NUREG/CR-2096
SAND81-0676

McGuire Nuclear Station Unit 1 Auxiliary Feedwater System Reliability Study Evaluation

ABSTRACT

This report presents the results of the review of the Auxiliary Feedwater System Reliability Analysis for the McGuire Nuclear Station Unit 1.

Figure 1 Simplified Flow Diagram of Auxiliary Feedwater System - William B. McGuire Station Unit No. 1 - Duke Power Company

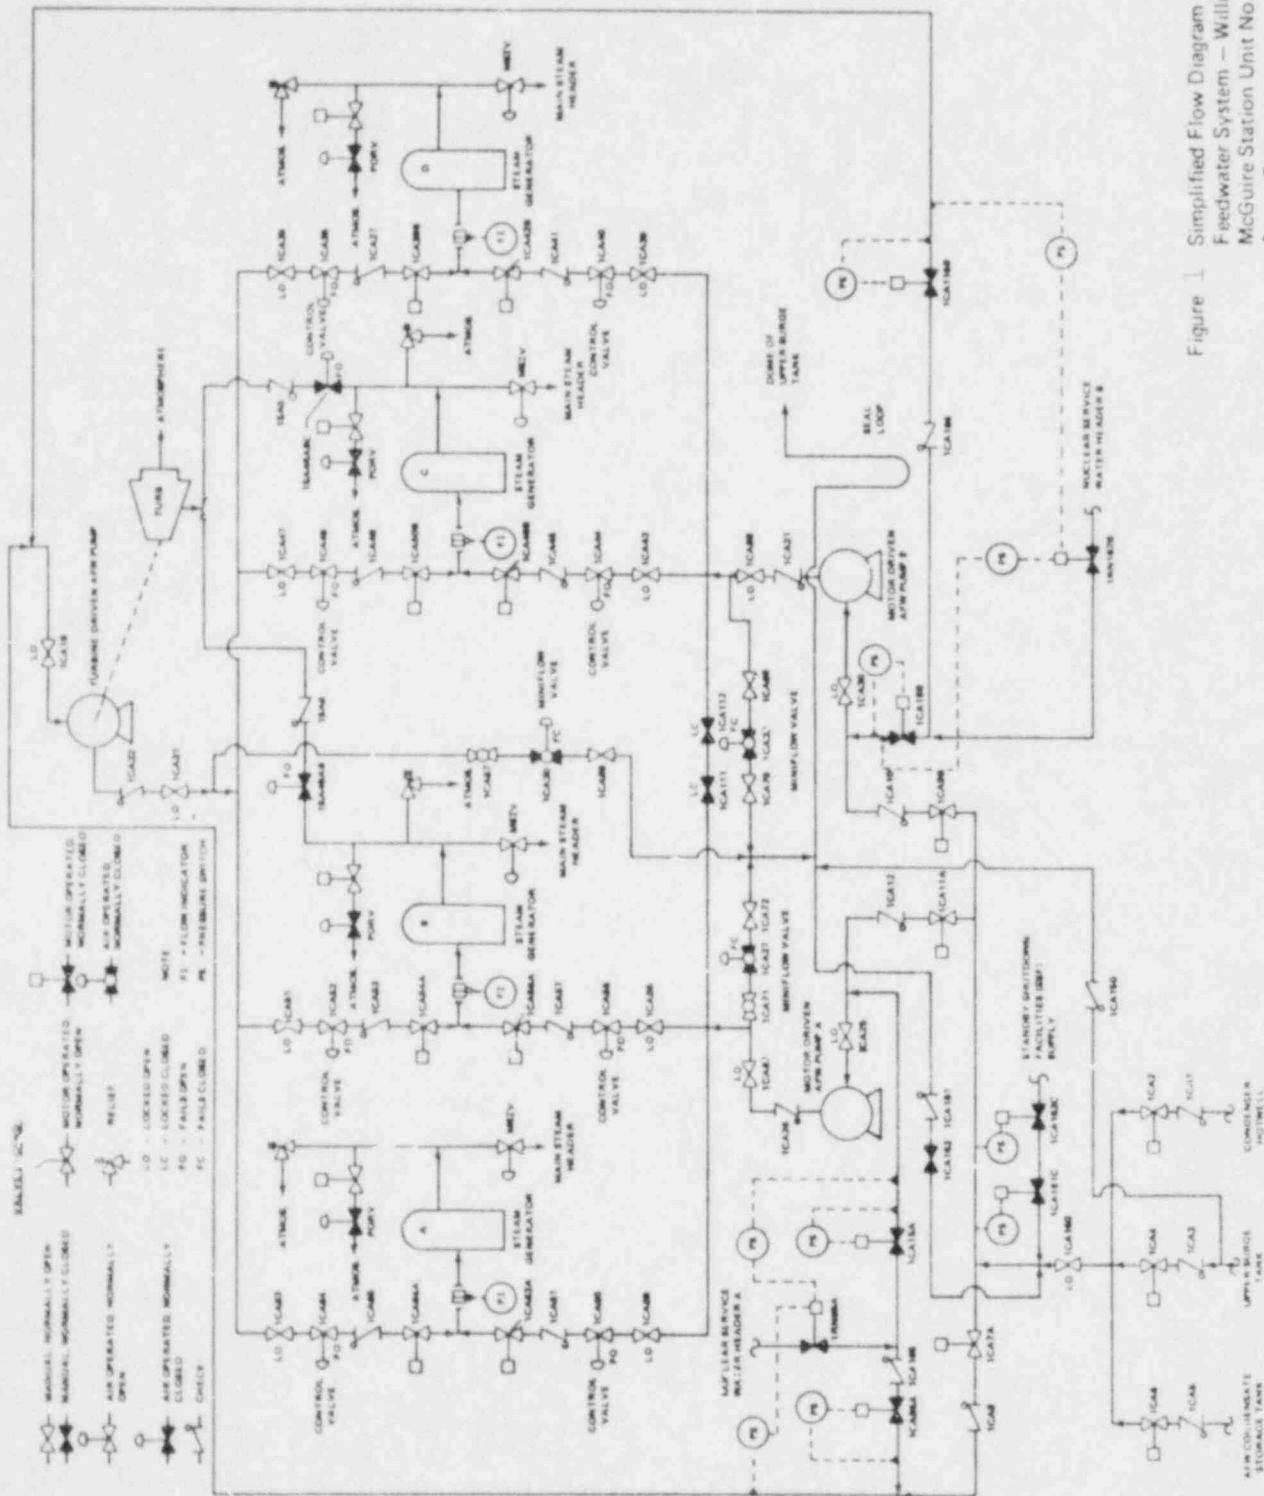
The report⁽²⁾ did not contain a table which included the Fault tree events. The fault tree was checked and all applicable components as shown in Figure 1 were properly included. Although the report states that the data in NUREG-0611 were used and the tables from NUREG-0611 reproduced as Appendix B, there was no way from the report review to verify this. At the meeting at McGuire, evidence was made available which showed that the analysis was made in great detail and that NUREG-0611 data were used.

Figure 2 Comparison of McGuire AFWS Reliability to other AFWS Designs in Plants Using the Westinghouse NSSS

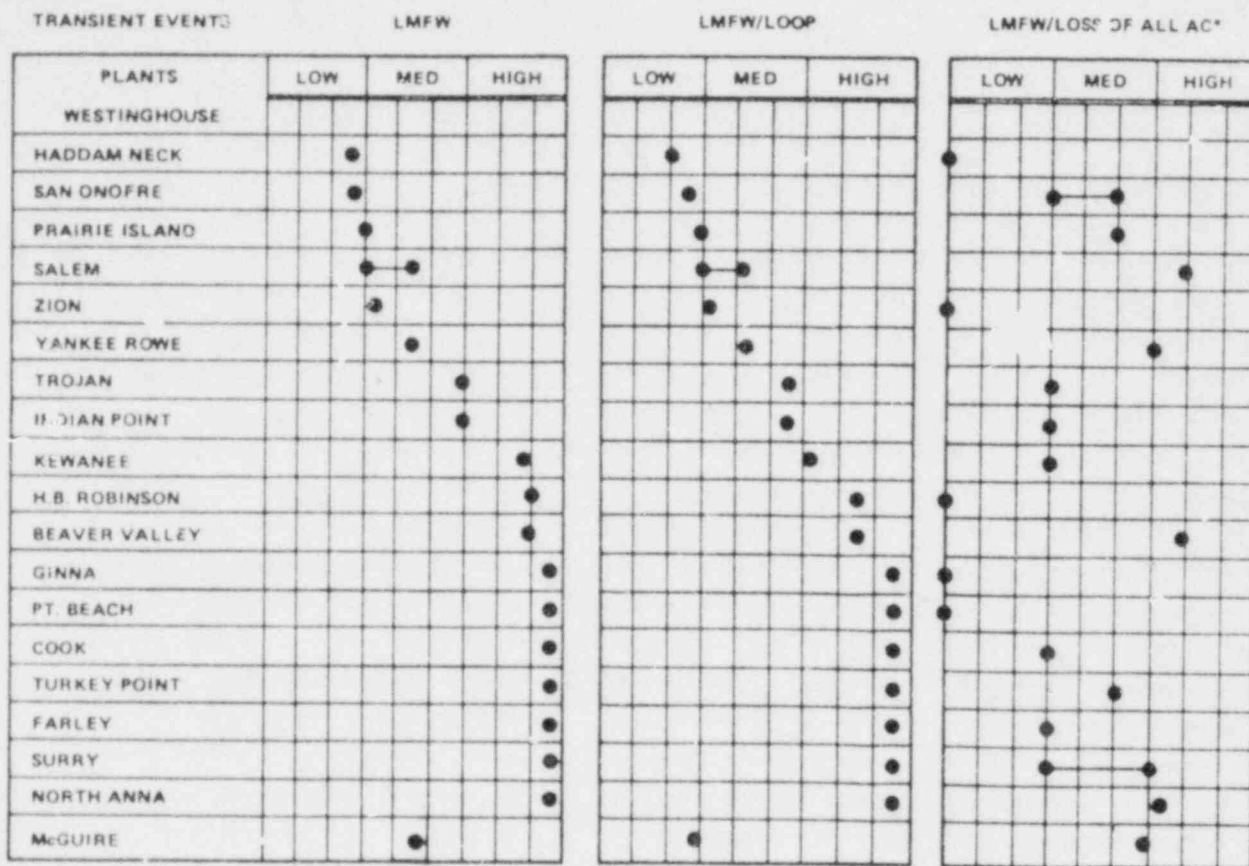
SNL agrees with the above listing. No quantification of results was made by DP in their report nor were results quantified in NUREG-0611. The quantitative estimates obtained from notes provided by DP are for Case 1 5.1×10^{-4} , for Case 2 1.2×10^{-3} , and for Case 3 1.2×10^{-2} . These values are plotted in Figure 2 along with the operating plant ratings which were derived from NUREG-0611. The McGuire AFWS has medium reliability for Case No. 1, LMFW; low reliability (high end) for Case No. 2, LMFW/LOCP; and medium reliability (high end) for

Case No. 3, LMFV/LOAC. Sandia agreed with these ratings after questioning the low reliability assessed for cases 1 and 2. Low reliability is caused not only by the events described above but also by the design. McGuire Nuclear Power Plant Auxiliary Feedwater System is throttled to provide protection for a fourth transient, break in the main feedwater line to or rupture of a steam generator. This precludes the pumps from delivering all the water to a main feedwater line break or ruptured steam generator. This in turn requires that more components be operable to support the three LMFV transients, and thus the lower reliability. Sandia agreed with this logic; however, it would seem that the flow control valves could be controlled so that they would automatically close on the receipt of a high flow signal as is done at the V.C. Summer Nuclear Power Plant.

The values determined above all fall into the high reliability area if plotted on Figure 2. No new fault trees or detailed calculations were submitted, however, if Westinghouse made these calculations in a manner similar to the original calculations, they should be correct. The changes appear logical and in line with the new assumptions made.
